SS 306 TBB HDX DEF Header Service Replacement Additional Parts

TBB HDX

DEF Header Failure replacement

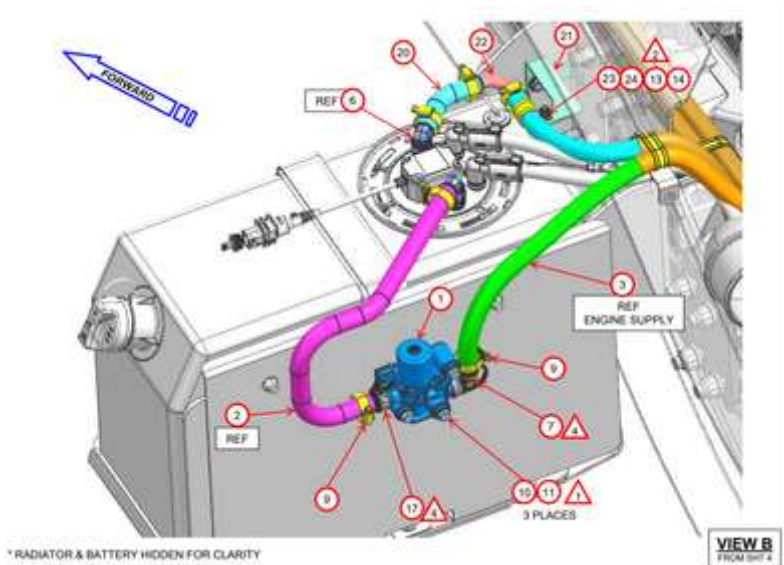
Original SSI DEF Header, which has been discontinued, has failed and needs to be replaced.

04-37614-000 must be used as replacement, but requires some additional parts and re-routing of DEF

Pump Supply Coolant line. Refer below for how item 20 is routed which you will need to reroute.

Note, the coolant line may need to be cut to length for better fit.

TBB 62410243 replace with 209494 HOSE - EPDM, 72 INCH LENGTH

TBB 62190462 replace with 209496 HOSE - SILICONE, 72 INCH LENGTH

TBB 162366 replace with TBB 209495 HOSE - BLUE STRIPE, 72 INCH Length
